Development Permit Panel

1. **DEVELOPMENT PERMIT 17-788728**
(REDMS No. 6065449 v. 3)

APPLICANT: Parc Thompson Project Inc.

PROPERTY LOCATION: 4300, 4320, 4340 Thompson Road and 4291, 4331, 4431, 4451 Boundary Road

BEFORE
CONVERSION

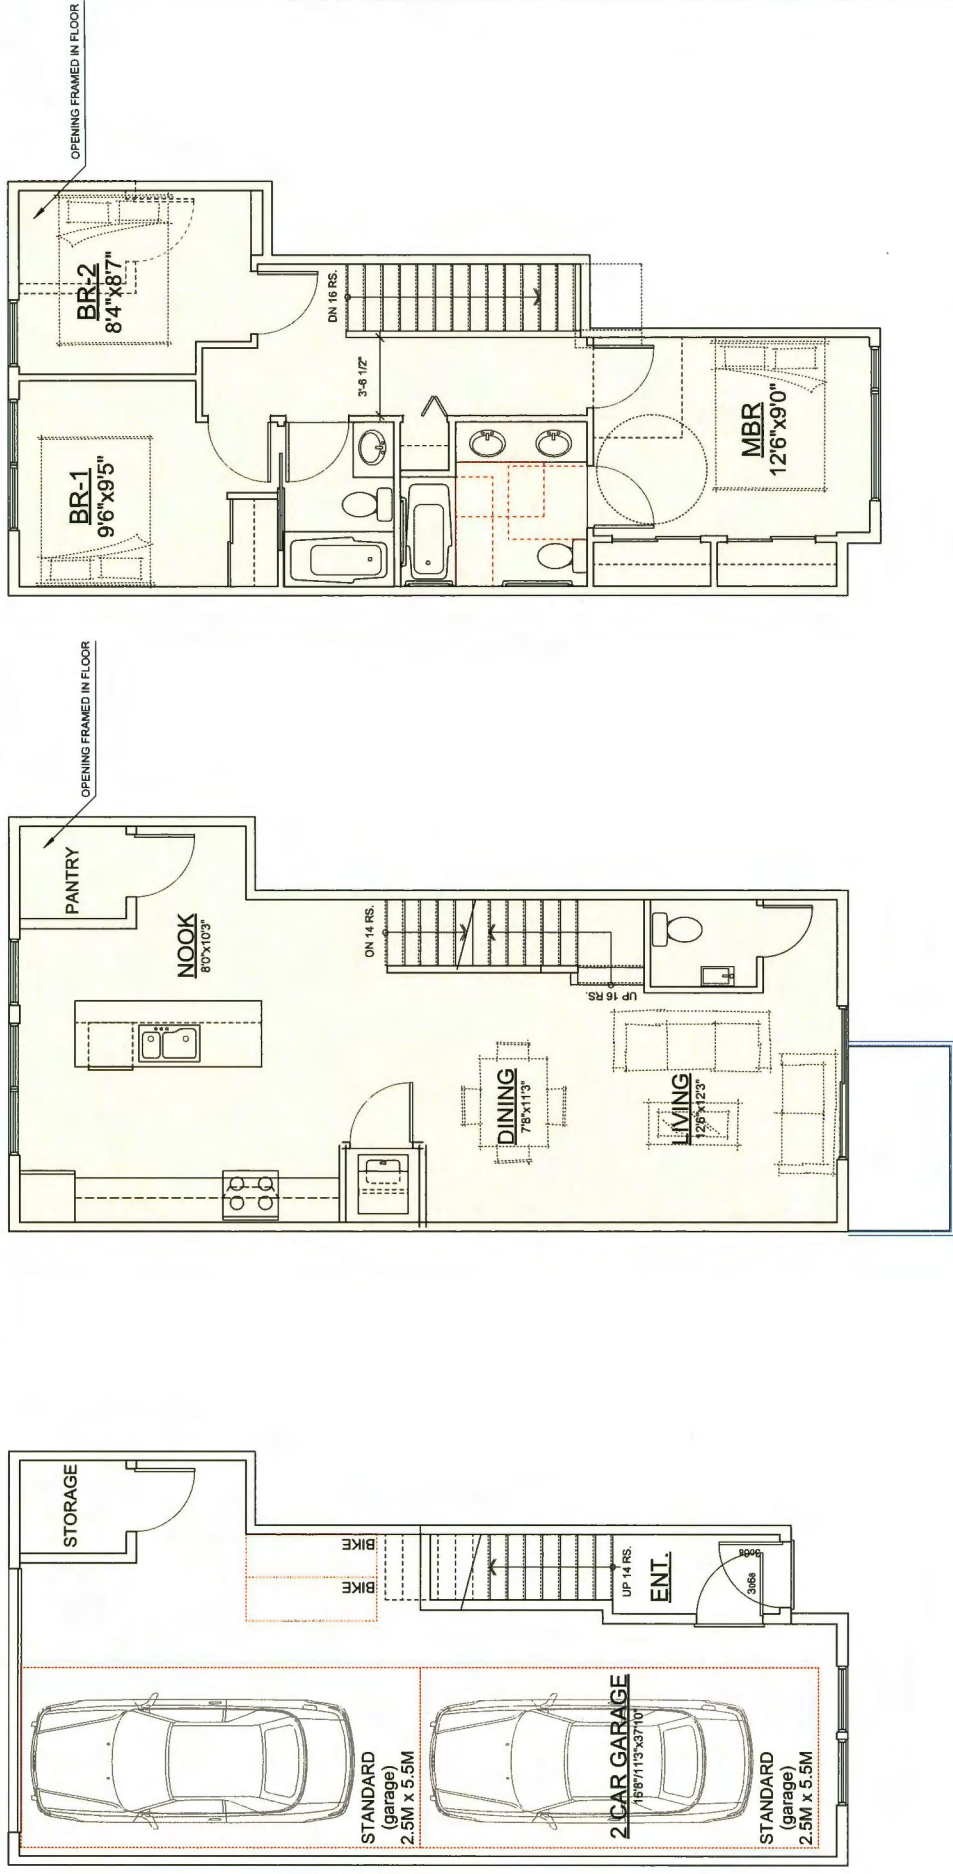
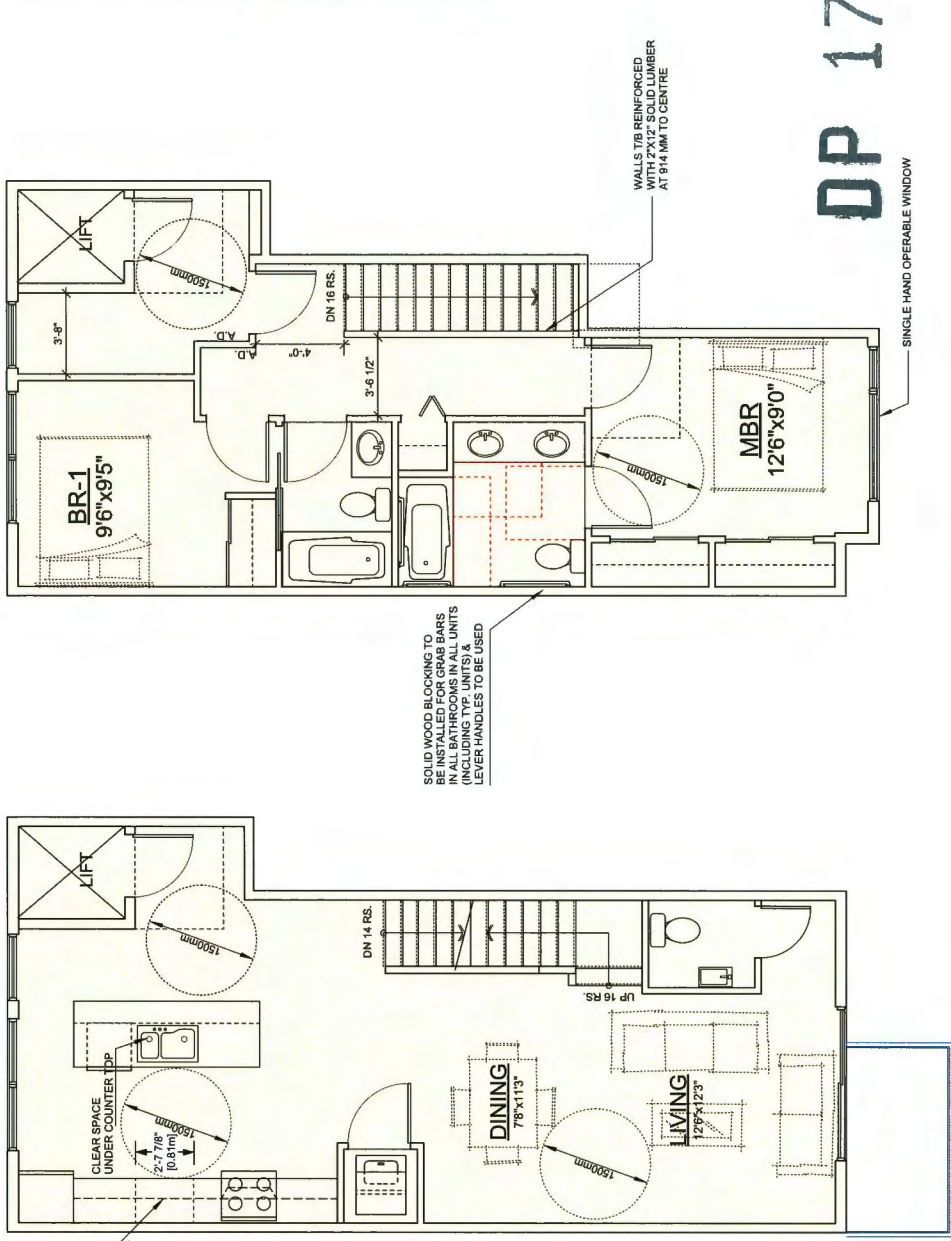
- the design of the convertible units is good; *Noted*
- consider installing an outward opening door towards the stairway for the powder room on the second floor of the convertible unit in lieu of an inward opening door to provide more usable space which could be accessed by a disabled resident; could be modified before conversion; ***Noted and revised to show the outward opening door.***
